**HISTORIC AND DESIGN REVIEW COMMISSION  
COMPLIANCE AND TECHNICAL ADVISORY BOARD**

<b>HDRC CASE NO:</b>	<b>2024-364</b>
<b>ADDRESS:</b>	218 DELAWARE
<b>LEGAL DESCRIPTION:</b>	NCB 3007 BLK 5 LOT 5
<b>ZONING:</b>	RM-4, H
<b>CITY COUNCIL DIST.:</b>	1
<b>DISTRICT:</b>	Lavaca Historic District
<b>APPLICANT:</b>	Chad Bradshaw/Mychal's Designs LLC
<b>OWNER:</b>	Patricia White/WHITE PATRICIA
<b>TYPE OF WORK:</b>	Front yard fencing installation
<b>APPLICATION RECEIVED:</b>	October 18, 2024
<b>60-DAY REVIEW:</b>	December 17, 2024
<b>CASE MANAGER:</b>	Caitlin Brown-Clancy

**REQUEST:**

The applicant is requesting a Certificate of Appropriateness for approval to install a 4'0" tall cattle-panel style front yard fence with a pedestrian gate and 12'0" gate spanning the driveway.

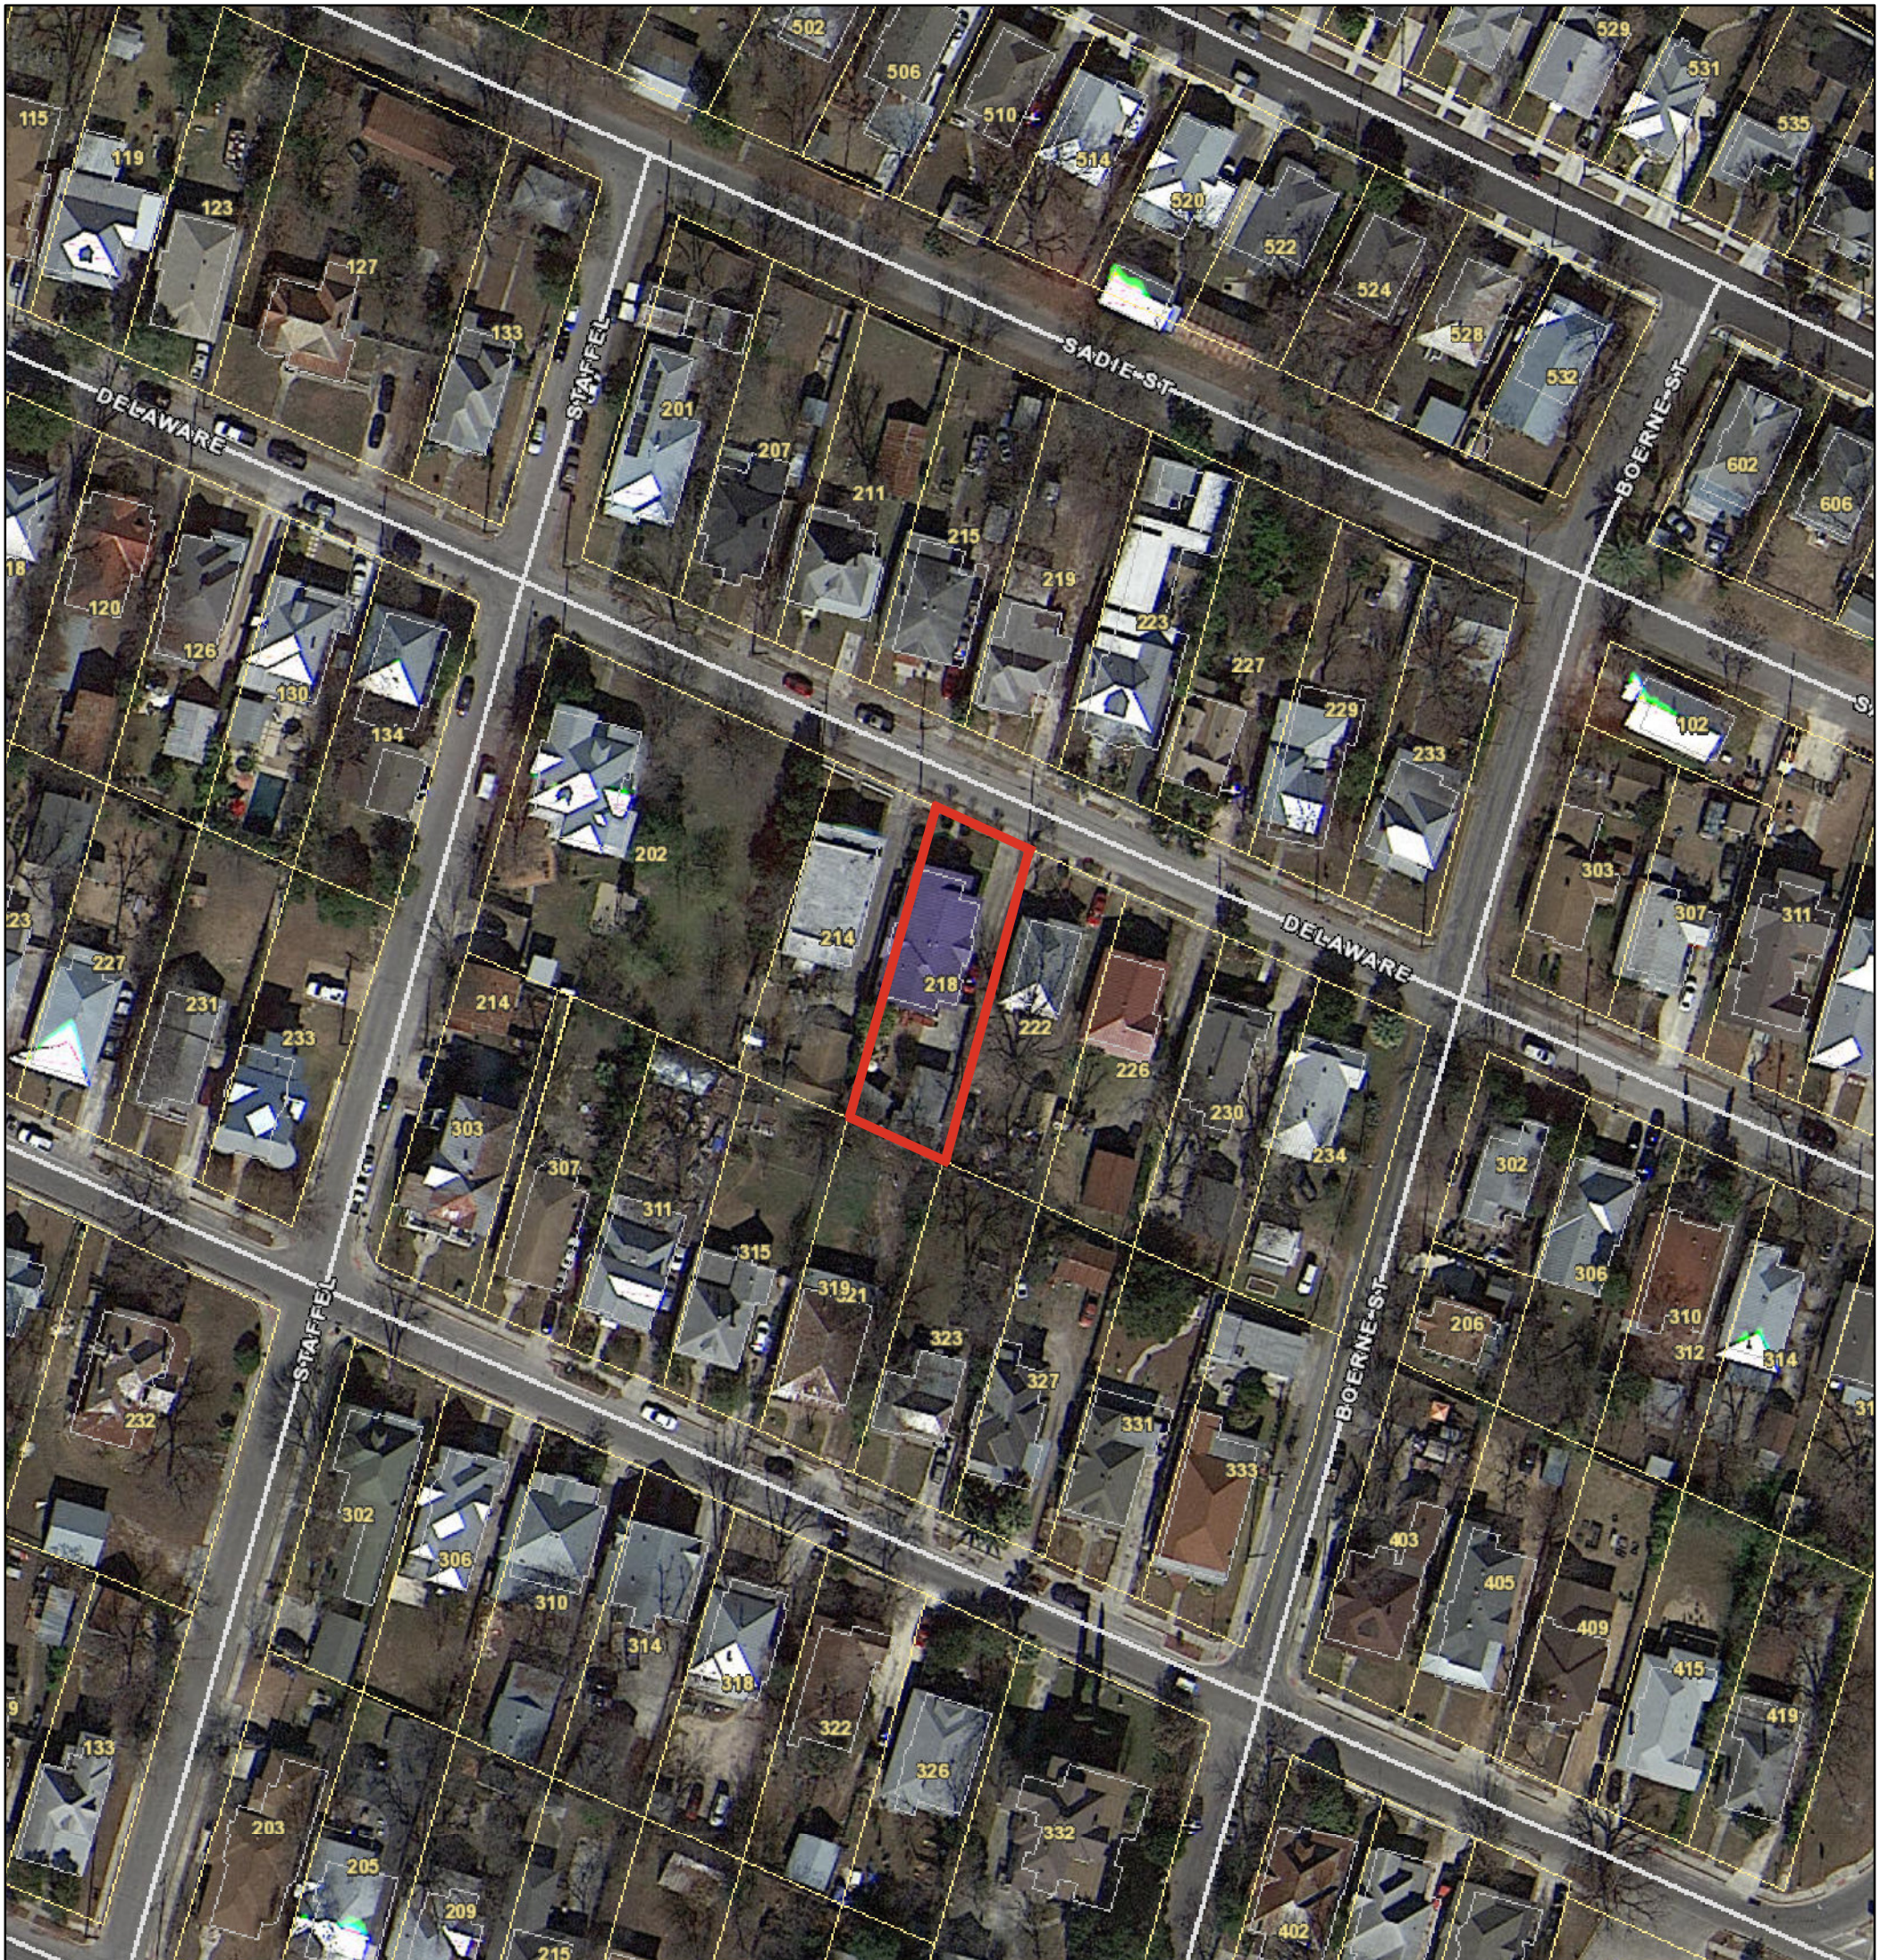
- c. FENCING (LOCATION) – The applicant is requesting to install a 4’0” tall cattle-panel style front yard fence with a pedestrian gate and 12’0” gate spanning the driveway. While the Guidelines for Site Elements 5.B.ii state that the appropriateness of a front yard fence or wall is dependent on conditions within the specific historic district the Fences Policy Guide stipulates that vehicle gates should be set behind the front façade plane of the house and not span across the driveway. Staff does not find the requested location to be appropriate.

- i. That the front yard fence return to the front facade at the driveway and that the vehicular gate is set behind the front façade plane of the house and not span across the driveway. Staff finds that the applicant shall submit updated drawings reflecting this stipulation prior to the issuance of a Certificate of Appropriateness (COA).
